Work Order ID 135095

Item Name: Crosstube Turning Detail

DRAWING NO. D206-667-141	TITLE CROSSTUBE ASS'Y (206B HIGH FWD)	REV. C	DART AEROSPACE LTD ENGINEERING ORDER		D.E.O. NO. D206-667-141-C-1	SHEET NO. SHEET 1 OF 1	SCALE NTS
DRAWN <i>9P</i>	CHECKED <i>ASS</i>	MFG. APPR. <i>JD</i>	APPROVED <i>MD</i>		DE APPR. <i>A</i>		
DATE 11.07.15	DATE 11.07.20	DATE 11.07.21	DATE 11/07/21		DATE 11.07.21

DRAWING NO. D206-667-141	TITLE CROSSTUBE ASS'Y (206B HIGH FWD)	REV. C	DART AEROSPACE LTD ENGINEERING ORDER		D.E.O. NO. D206-667-141-C-2	SHEET NO. SHEET 1 OF 1	SCALE NTS
DRAWN AJS	CHECKED	MFG. APPR.	APPROVED	DE APPR.			
DATE 12.08.02	DATE 12.08.02	DATE 12.08.02	DATE 12.08.02	DATE 12.08.02

BONDING STRAP INSTALLATION 2 PL

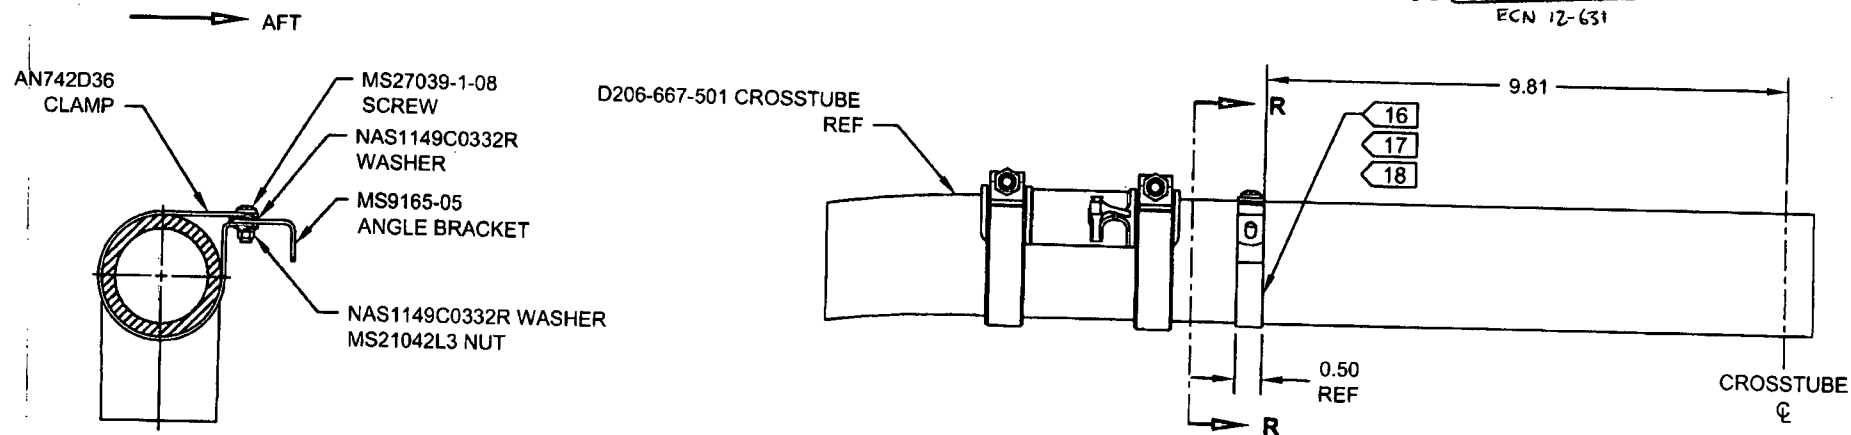
PURPOSE:

ADD ELECTRICAL GROUNDING STRAP

PARTS LIST:

ITEM	QTY -141	PART NUMBER	DESCRIPTION
1	X	D206-667-141	CROSSTUBE ASSEMBLY (206B HIGH FWD)
10	2	AN742D36	CLAMP
11	2	MS9165-05	ANGLE BRACKET
12	2	MS21042L3	NUT (OR MS21042-3)
13	2	MS27039-1-08	SCREW
14	4	NAS1149C0332R	WASHER (OR AN960C10L)

- 16) MASK AREA UNDER CLAMP PRIOR TO PAINTING
- 17) SEAL EDGES WHERE AN742D36 CLAMP MEETS WITH THE CROSSTUBE USING SIKAFLEX-241/-291 OR MIL-S-8802 CLASS B2 OR PROSEAL 890 SEALANT
- 18) PERFORM RESISTANCE CHECK TO ENSURE MAX RESISTANCE IS 10 MILLIOHMS
